Addendum #2

VA Project No.: 553-21-100

Project: Renovate A2 South for Cancer Clinic
John D. Dingell VA Medical Center
Detroit, Michigan

Date: May 1, 2026

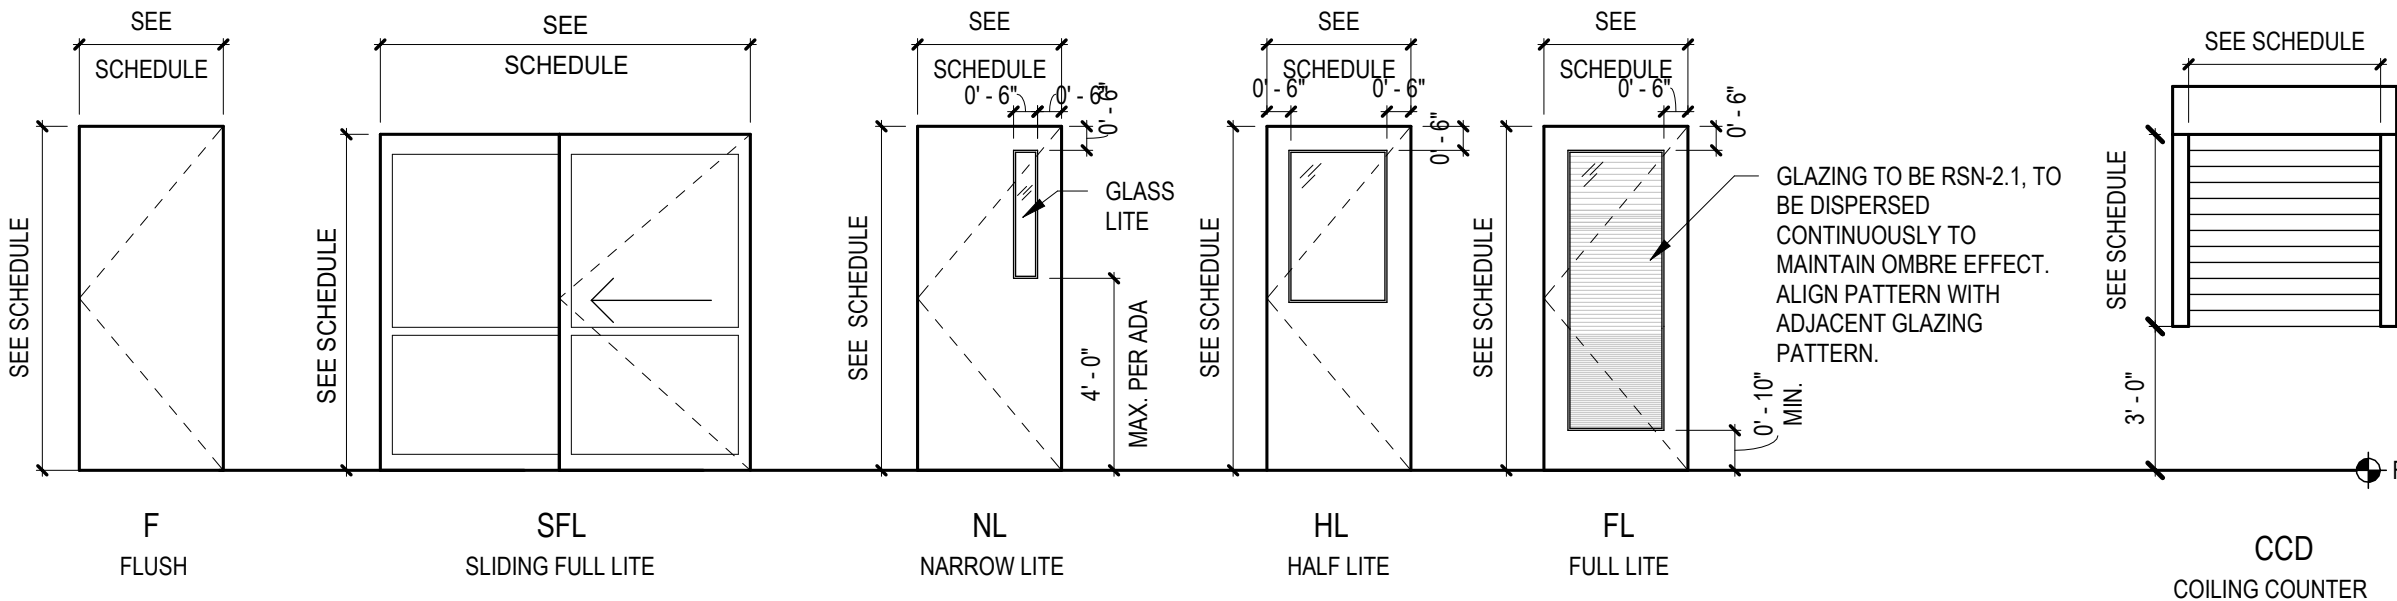
- A2.7 Refer to Sheet A-403 (reissued):
Revise infusion bay casework.
- A2.8 Refer to Sheet A-405 (reissued):
Add side splash to countertops.
- A2.9 Refer to Sheet A-506 (reissued):
Revise detail as shown.

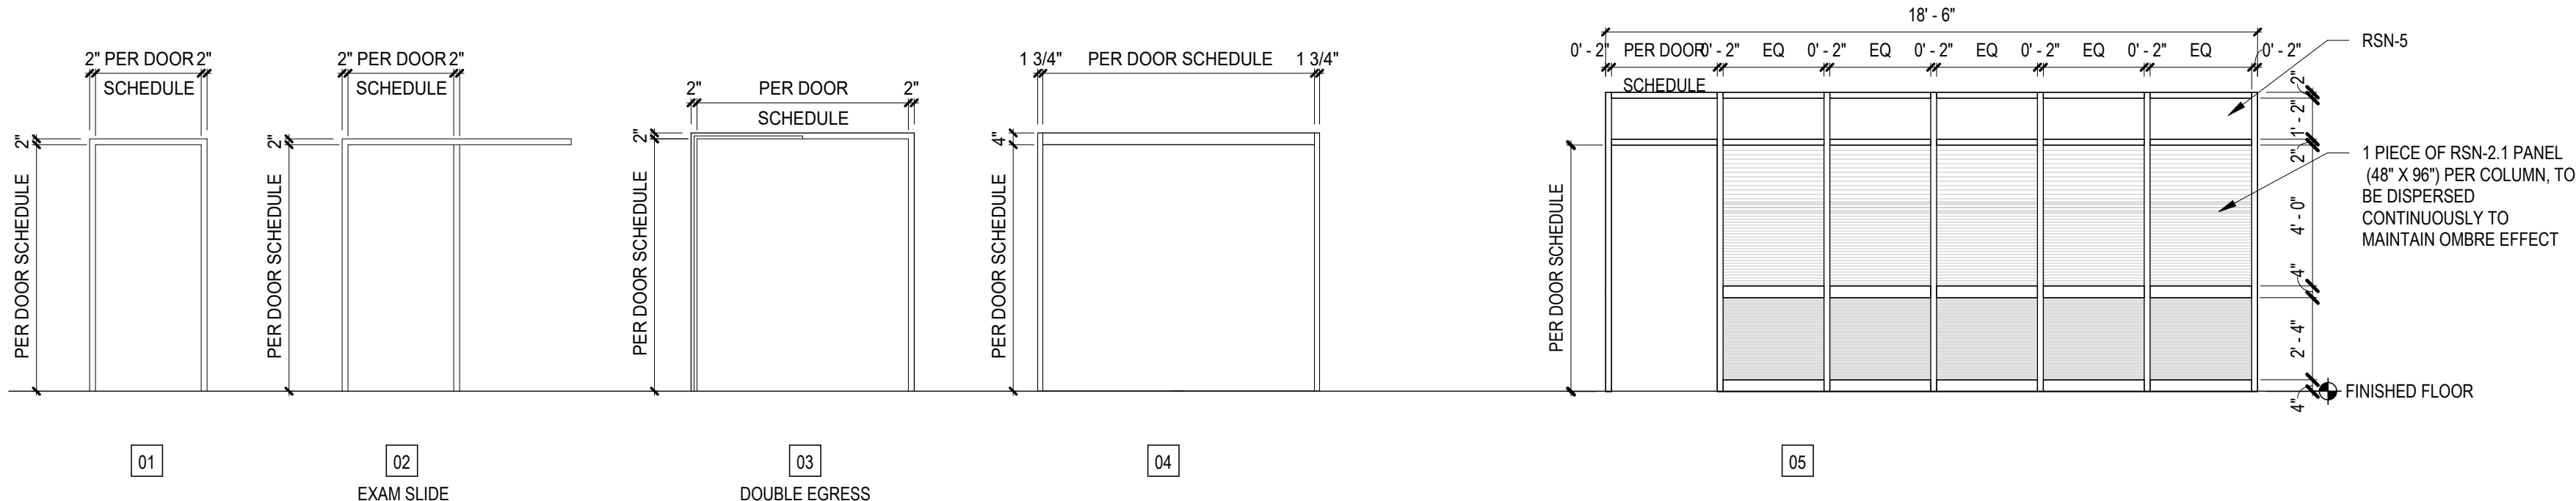
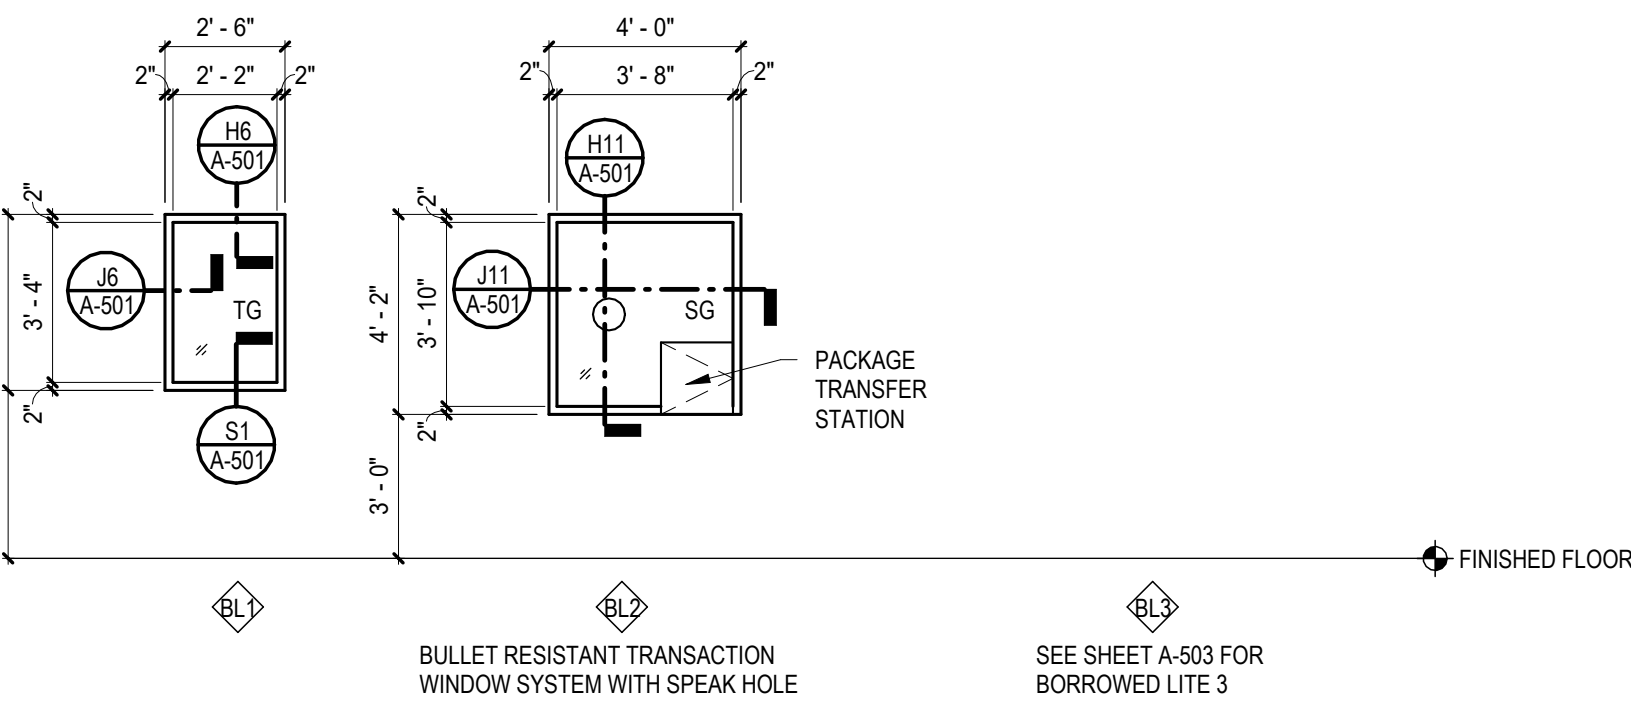
- A2.10 Refer to Sheet A-601 (reissued):
Revise door and frame schedule.
- A2.11 Refer to Sheet I-001 (reissued):
a. Revise wall protection heights and trim.

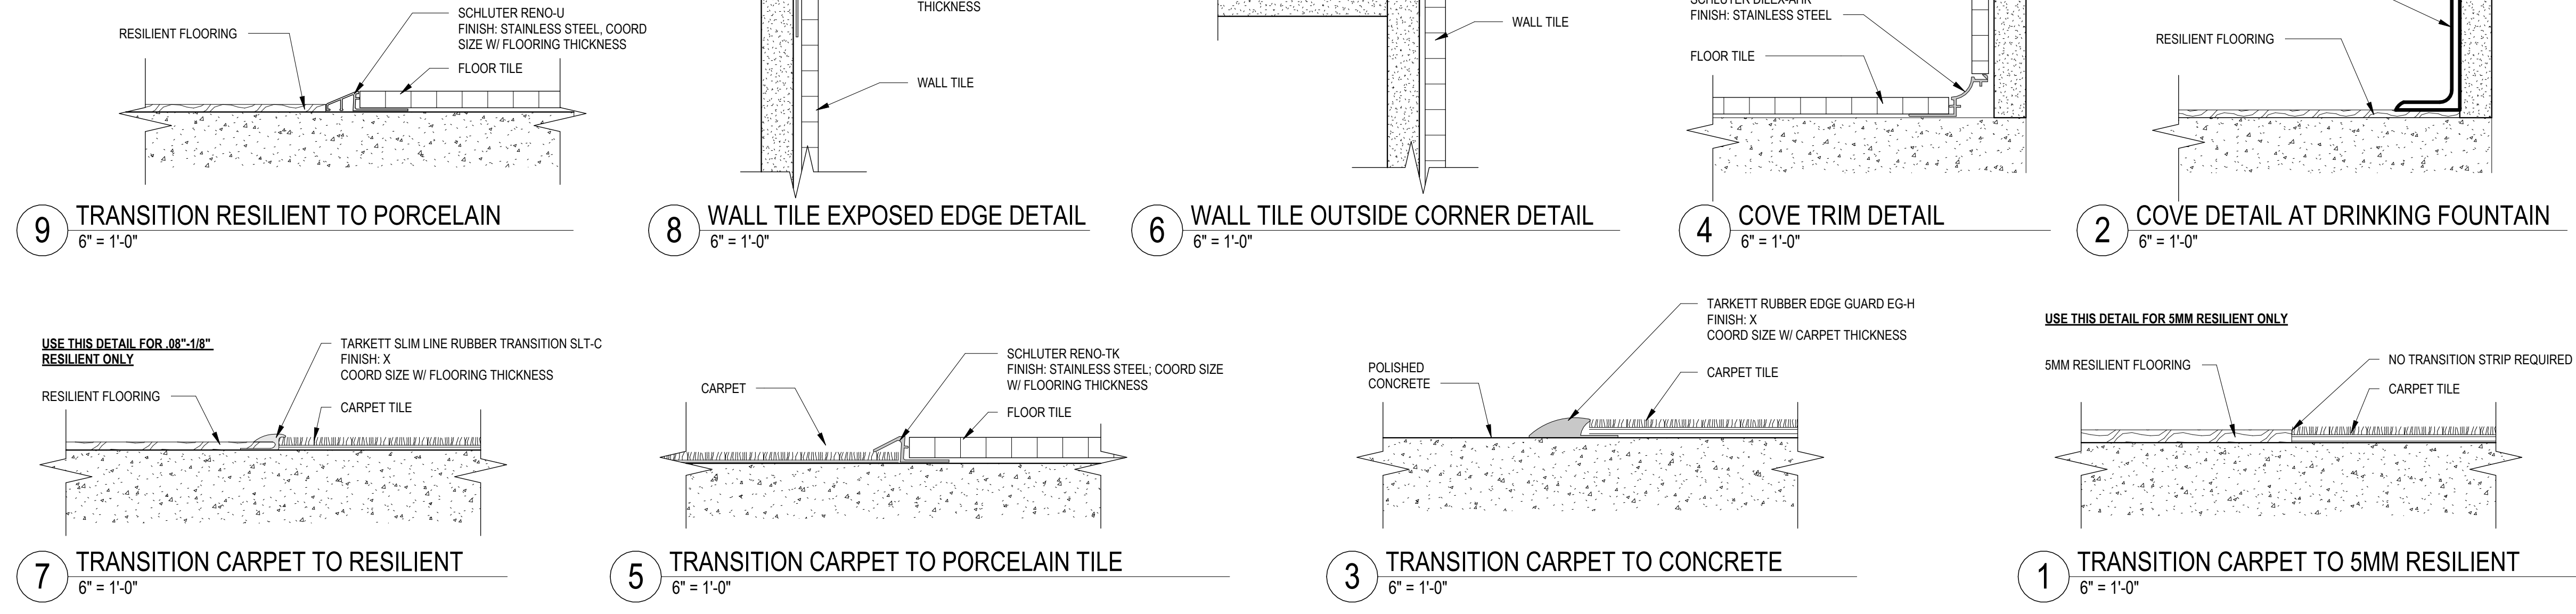
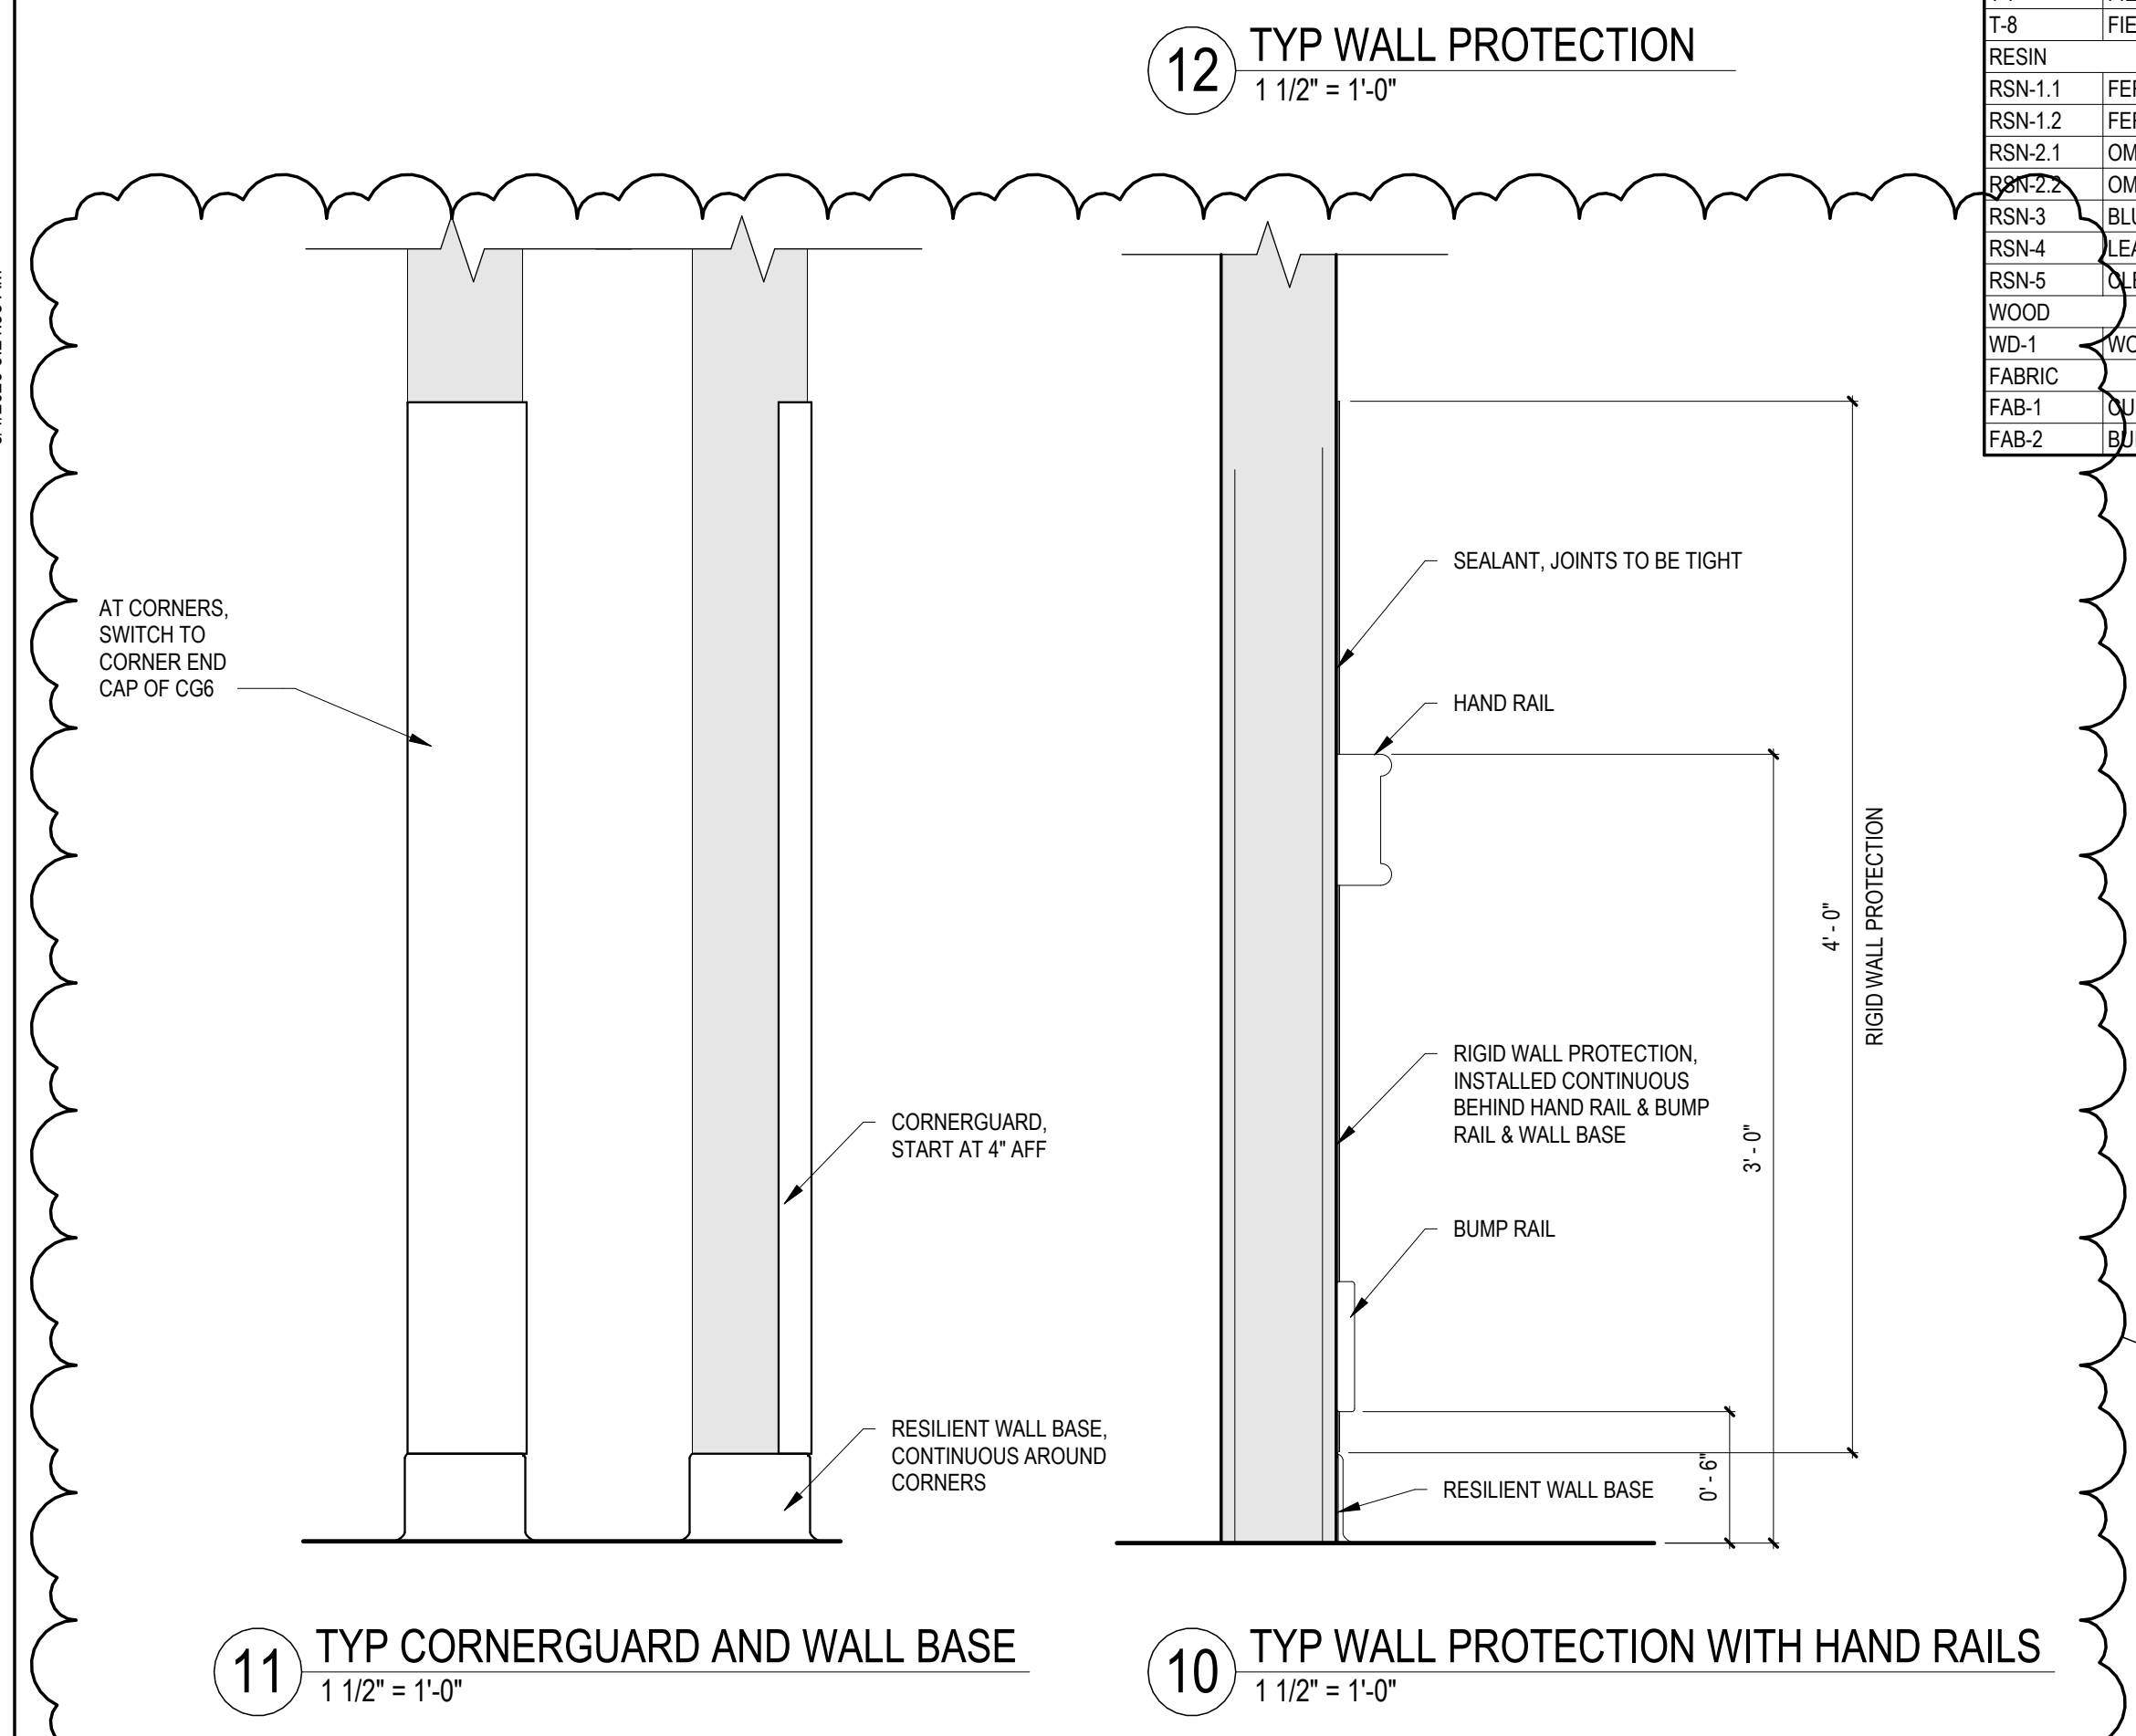
b. Add corner guards.
- A2.12 Refer to Sheet I-102.1, I-102.1A, I-102.1B, I-102.1C, and I-102.1D (reissued):
Revise legend.
- A2.13 Refer to Sheet I-102.1C (reissued):
